# **Blount County**

#### **MEMORANDUM**

Site Plan review for clubhouse and pool at Manor in the Foothills Subdivision at

3105 Farmhouse Road

A2.0

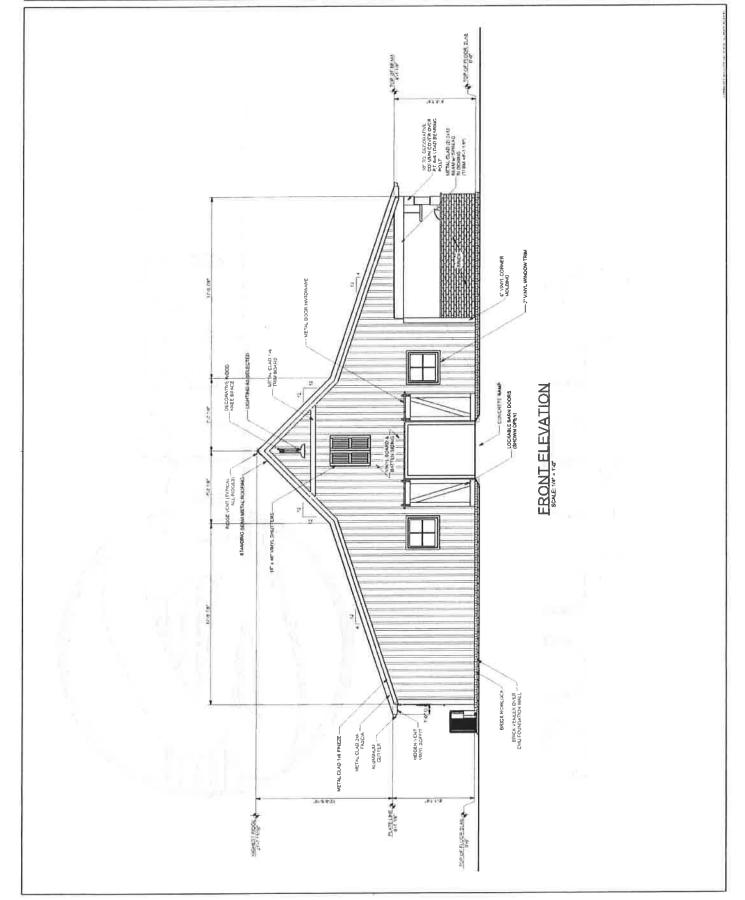
Per section 7.2.I., all Site Plan submissions are required to conform with the design requirements in section 7.15. The proposed development, per the submitted elevations, demonstrates compliance with this section by incorporating non-metal materials such as vinyl, brick, and glass.
